Nº1 READING

29-35 Station Road, Reading, Berkshire

Reading Design Review Panel - Design Response

Issue 2	24th June 2019	Planning Issue
Issue 1	31st May 2019	Draft 1

Ground Floors - ‘Waistband’

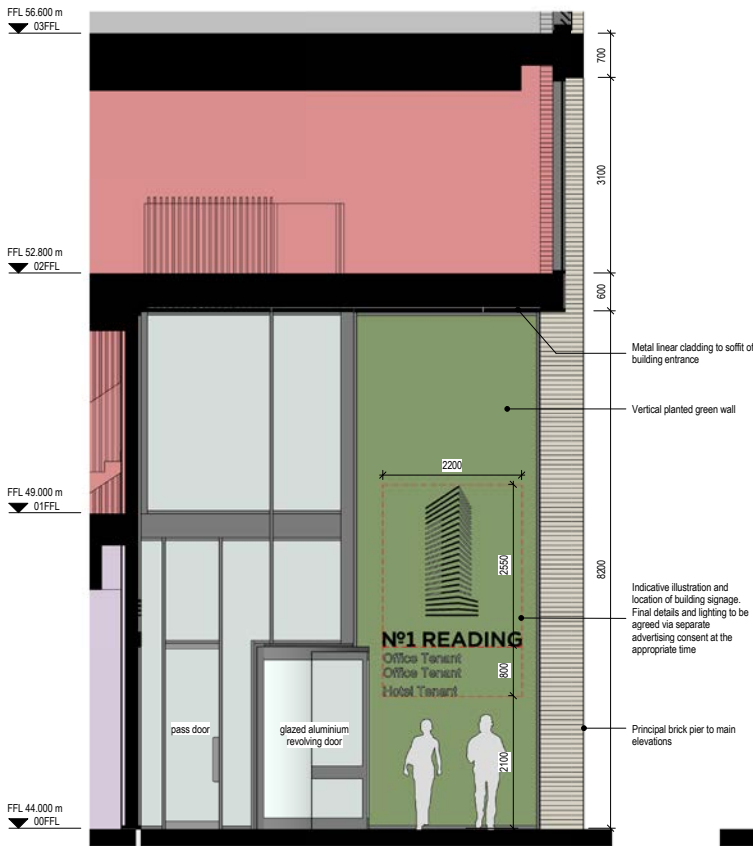
“The DRP commented that the “waist belt” covering the plant floor could work as a ventilated or back lit element. Visually it would read better to have this an extension to the glazing on the lower floors (as a curtain over the glazing) and back lit, (so the glazing slides behind it) rather than as part of the dark grey panel sections.”

Response

We have revised the base of the tower to respond to this comment. Having reviewed the design with the waist band as an extension to the lower glazing we felt that this made the base of the tower proportionally too tall within the streetscape. Maintaining the base section as three storeys and having clear articulation between the base and upper floors maintains the proportional relationship with the listed former Great Western Hotel and the street scene.

The proposed response boldly articulates the base and upper sections of the tower creating a stronger waist band which underlines the importance of the relationship in scale to the former Great Western Hotel (Malmaison) opposite and to the street scape of Station Rd and Garrard St. The waist band also relates strongly with the mansard roofscape typical of neighbouring buildings.

Middle Floors

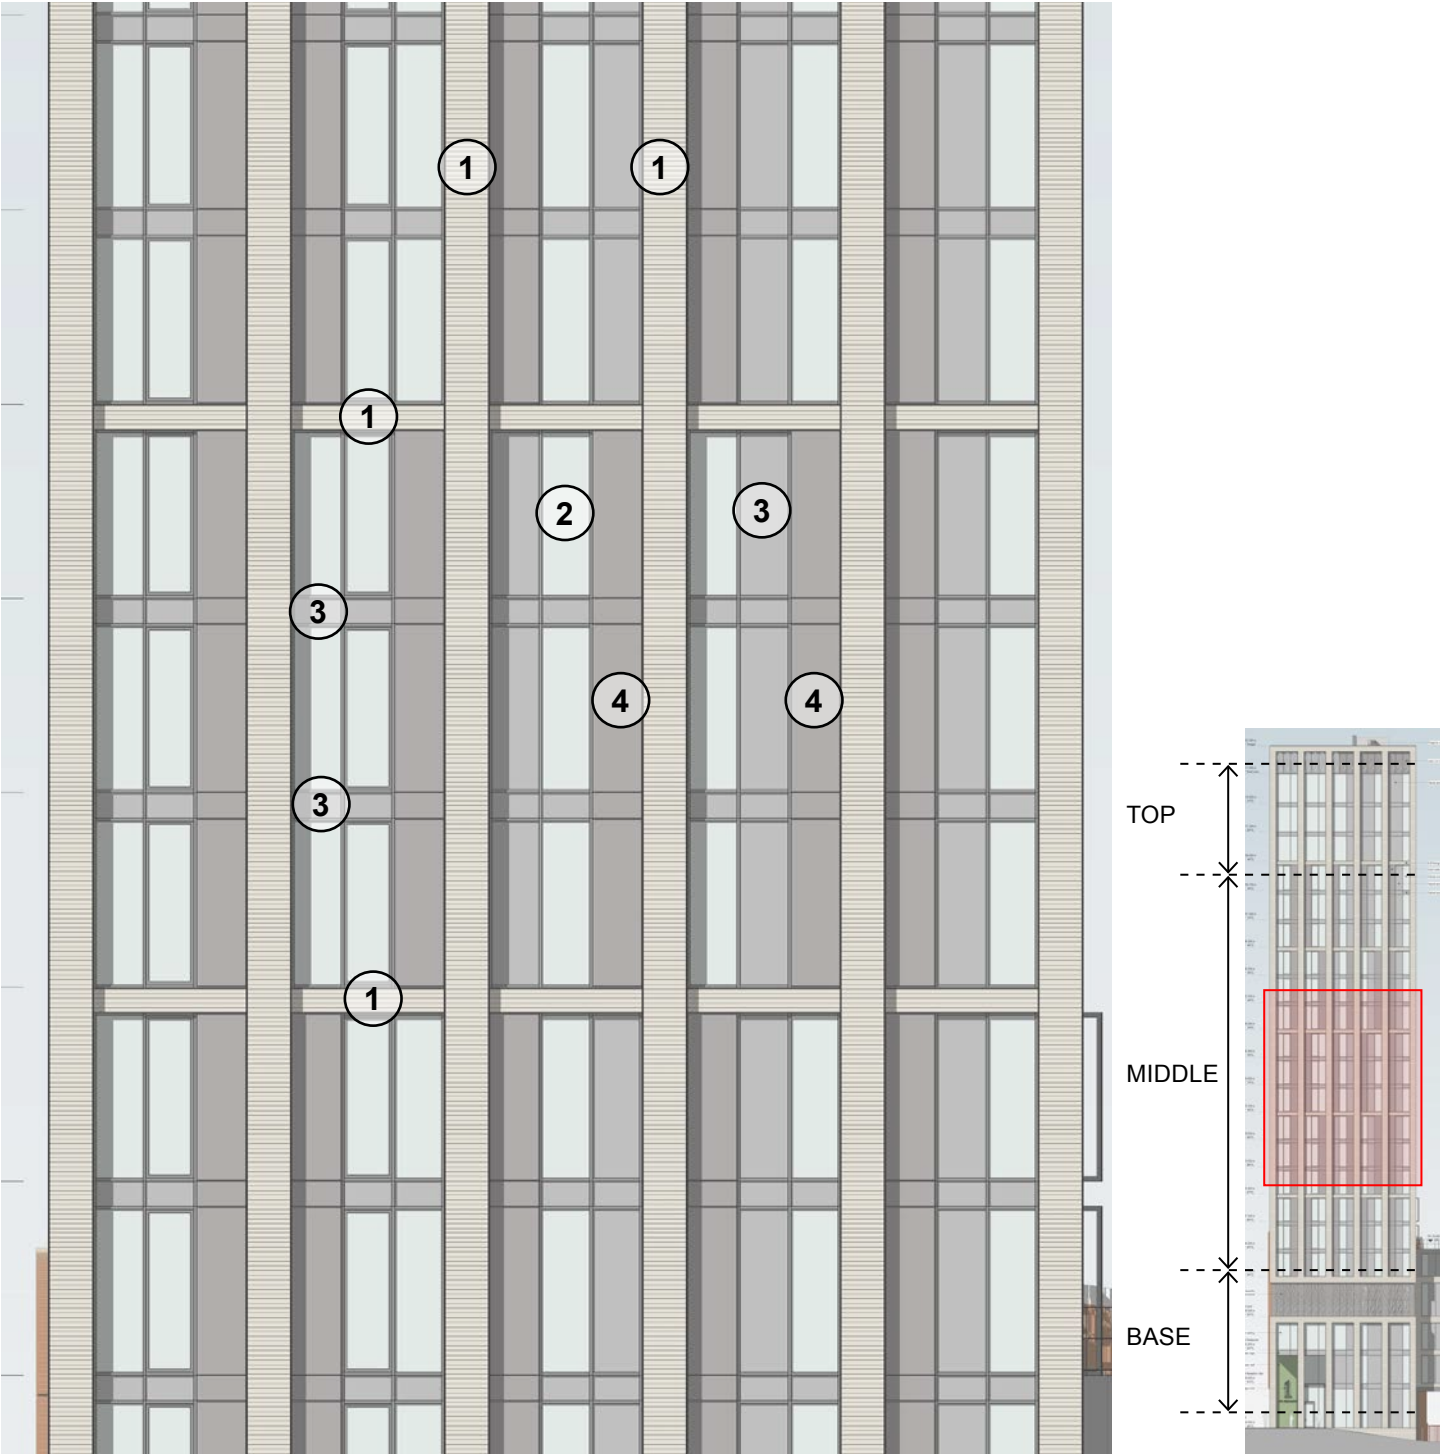
“Proportionally, the grid looks convincing from different distances and the white brick approach is interesting. The middle section was agreed by the DRP as being the weakest section as concerns were raised over the low proportion of window to panel. Visually this section was described as being the “second class part of scheme” and needs to be improved. Aesthetically this section may look better if the glazing was more generous on this part of the facade.

The randomisation across this section does create movement, but the DRP didn’t feel this was necessary and making this movement more subtle may simplify this area. If the concept is to increase the lightness and glazing as you move up the tower facade, this could be played out more convincingly by introducing much more glazing lower down in the building rather than just at the top two bands of the middle section.”

We have reviewed a number of alternative designs associated with these comments and remain content that the middle section of the tower will be of high quality. The proportions of the glazed and solid elements within the facade have been flipped and thus increasing the proportion of glazing to the hotel rooms from one-third to two-thirds. We have prepared a few visuals of each section of the tower to assist in understanding the relationship between the different materials.

In response to the above comments we have made a few subtle changes to the grid to help strengthen and simplify the central section of the tower. These are changing the horizontal buff stone to a brick to match the vertical brick and to increase the horizontal grid to three floors from two. We feel these subtle changes strengthen the grid and simplify the materials palette in line with the DRPs comments.

Upper Floors

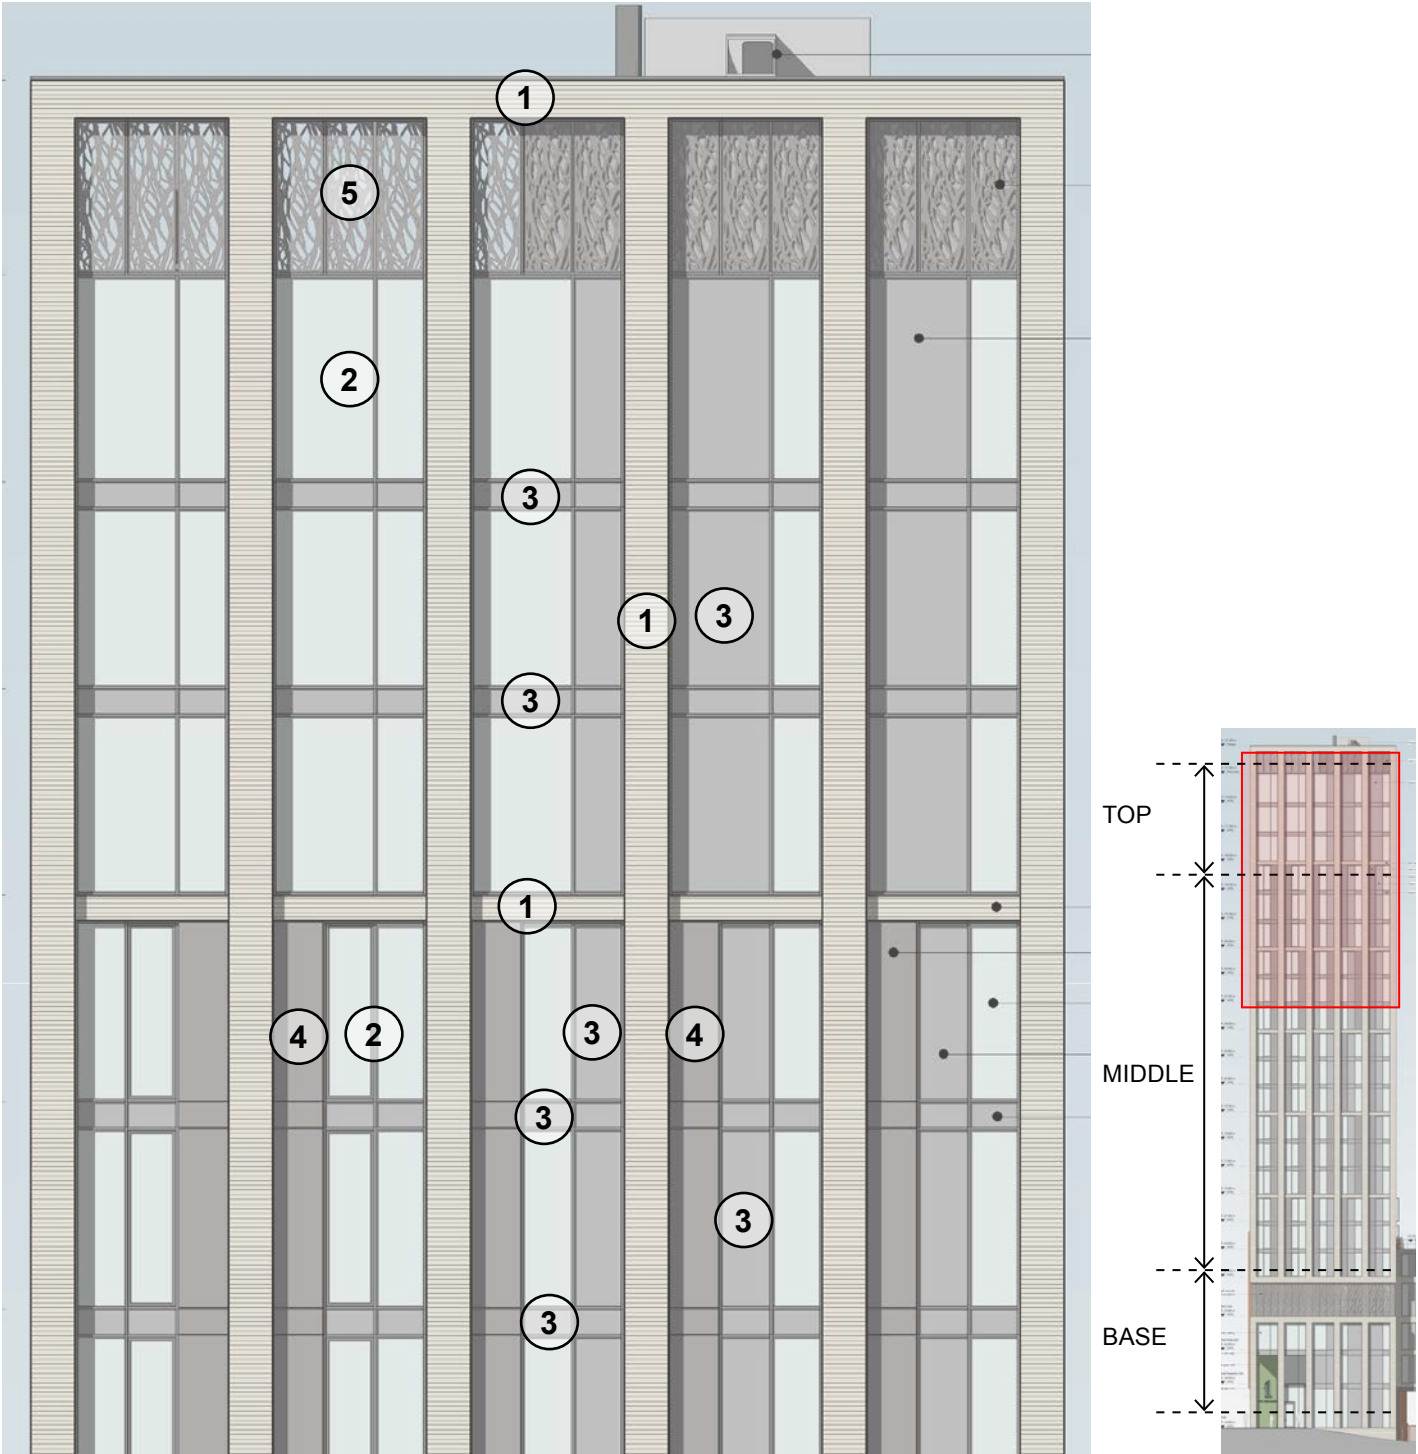
“The DRP commented that the large areas of glazing work well in this areas but frame depth and reveals will key to this scheme in terms of ensuring quality in the design (see more on this below). The DRP questioned whether fins are necessary at these top levels and how much shading they would actually provide into the spaces (could the laser panels be used as a shading curtain in areas?). Proportionally the uppermost bay could be taller to really emphasise the laser cut panels and top lid to the scheme. Thought should be given to this pattern and whether larger signage could be introduced at this level.”

As noted above we have revisited the materiality of the grid and its horizontal setting out. We have enhanced the proportions of the upper floor grid as well in line with the DRPs comments. We are happy that the thermal modelling we have carried out to validate the energy statement requires the vertical fins and they provide valuable shading to reduce heat gains.

Dark Infill Cladding: Proportions

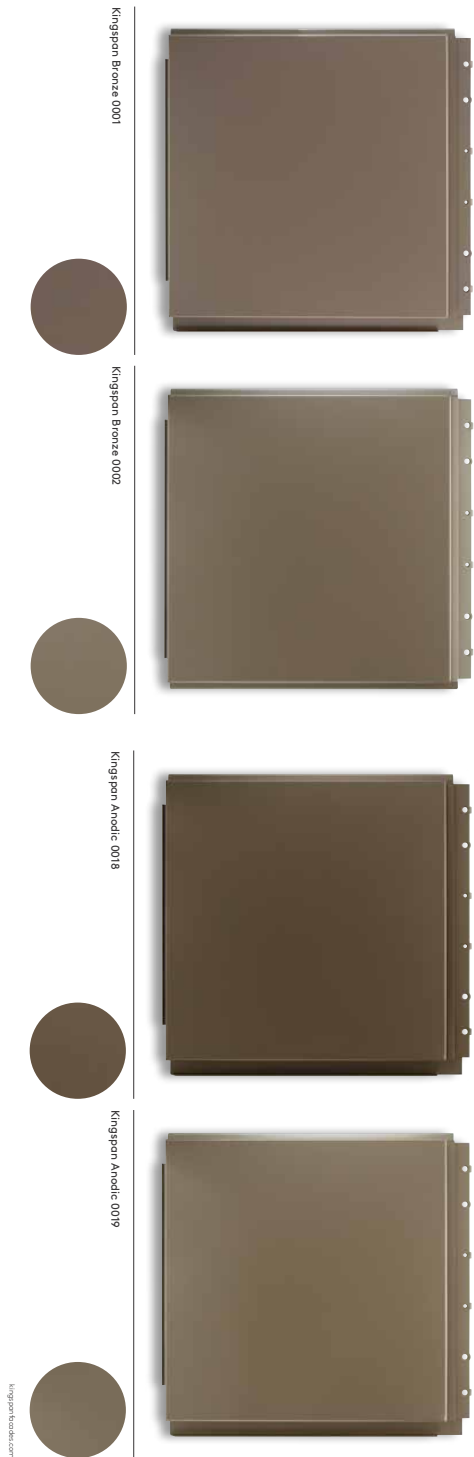
“The DRP would like the central section of the scheme to be developed particularly where opaque panels are noted. Spandrel panels are introduced on the upper and lower sections of the scheme with some being taken down into the central section of the elevations in places, these will appear as more reflective and lightweight.

The quality these opaque panels will be important to the proposal especially as these appear quite dark and heavy on the elevations. This may be improved by increasing the ratio of glazing in each of the bays (as on the corner windows) and introducing more spandrel panels.

More details and justification of this approach alongside the specific materiality of these panels should be provided to convince the panel of the quality and aesthetic of the panels.”

As noted previously the proportion of the windows to the central section have been increased.

The solid metal panels are a folded metal cassette panels. This will have a high quality finish with a warm grey to brown powder coated finish. The final colour will be chosen alongside the brick selection. Fixings will be concealed within the folds of the panel system.

The cladding systems will also be selected to ensure appropriate fire testing with fire cavity barriers to openings and floor levels in line with building codes for tall buildings.

Artist Impression along Garrard Street illustrating revised building corner

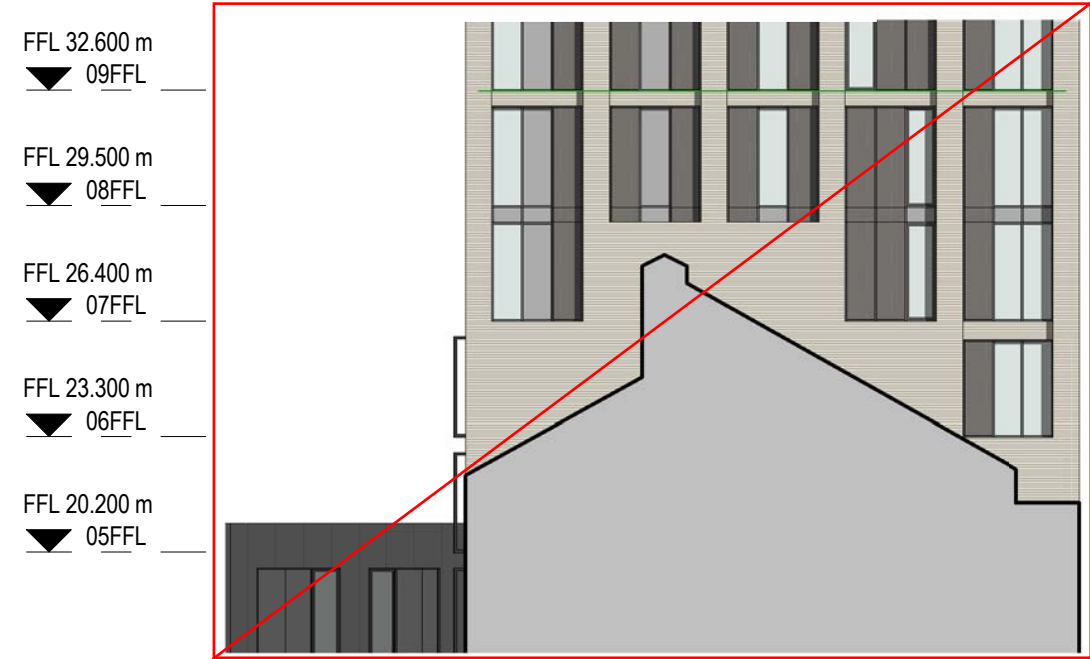
Maintaining the strength of the grid and corner is key and breaking the corner of this frame with narrow windows (such as on areas of the north elevation next to the Garrard House) doesn't add any benefit and weakens the design so should be revisited.

This has been addressed on the revised elevations. See also adjacent view along Garrard Street.

Brunel House Abutment Options

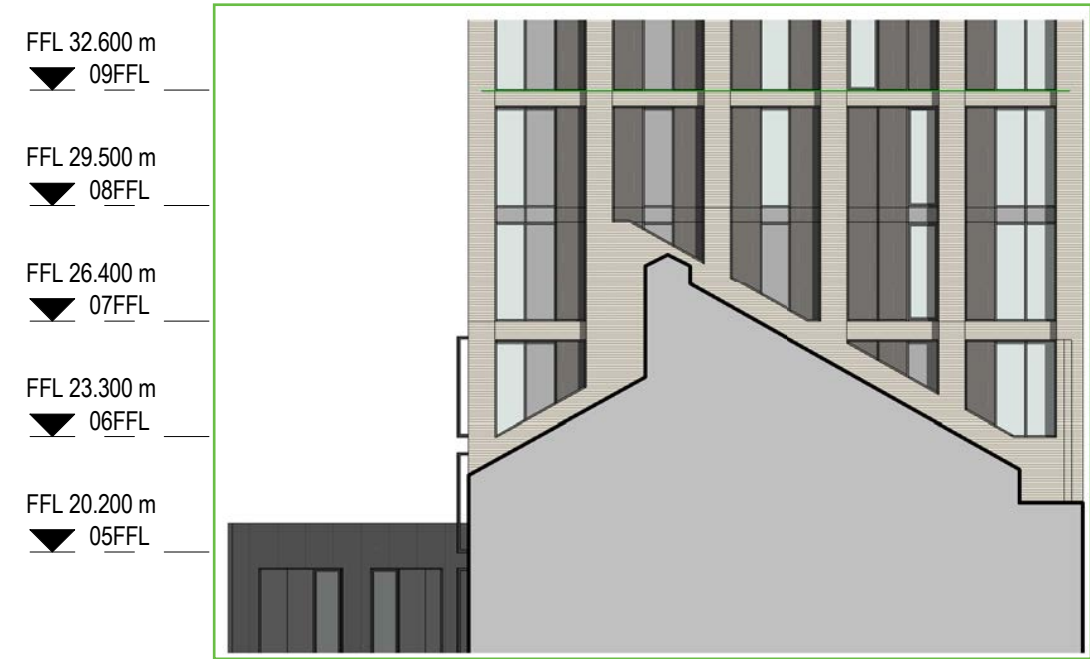
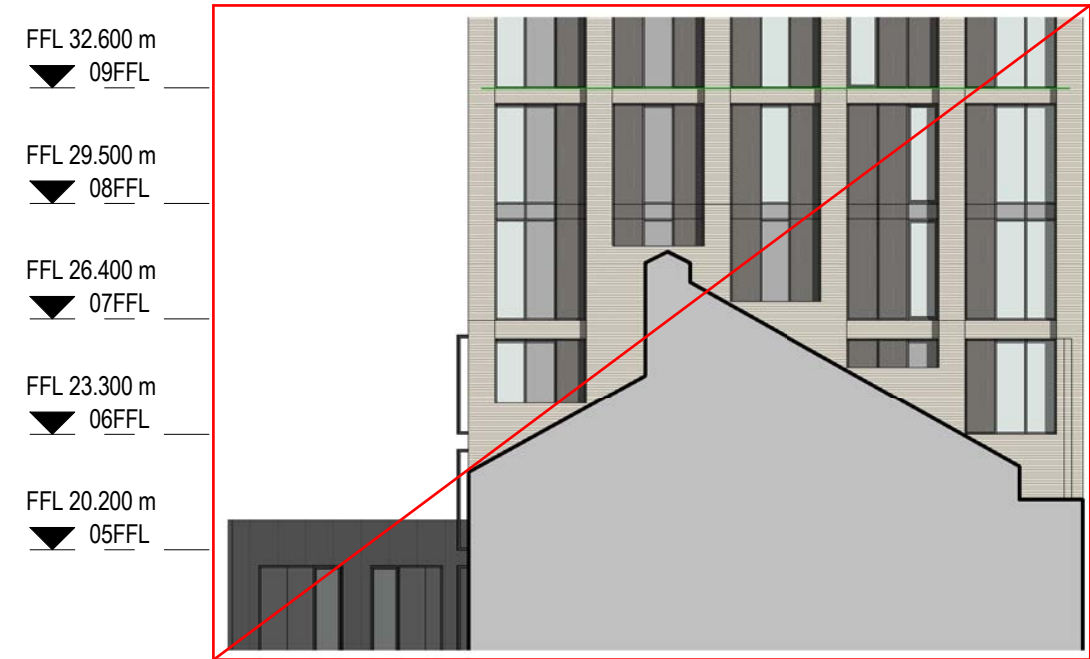
The junctions between existing buildings abutting the proposal need more finessing and thought. Particularly, the gable edge roof junction to Brunel House along the south elevation needs to be revisited. Dressing up to this edge of the gable may help the overall effect.

This has been addressed on the revised elevations. See also adjacent view along Station Road.
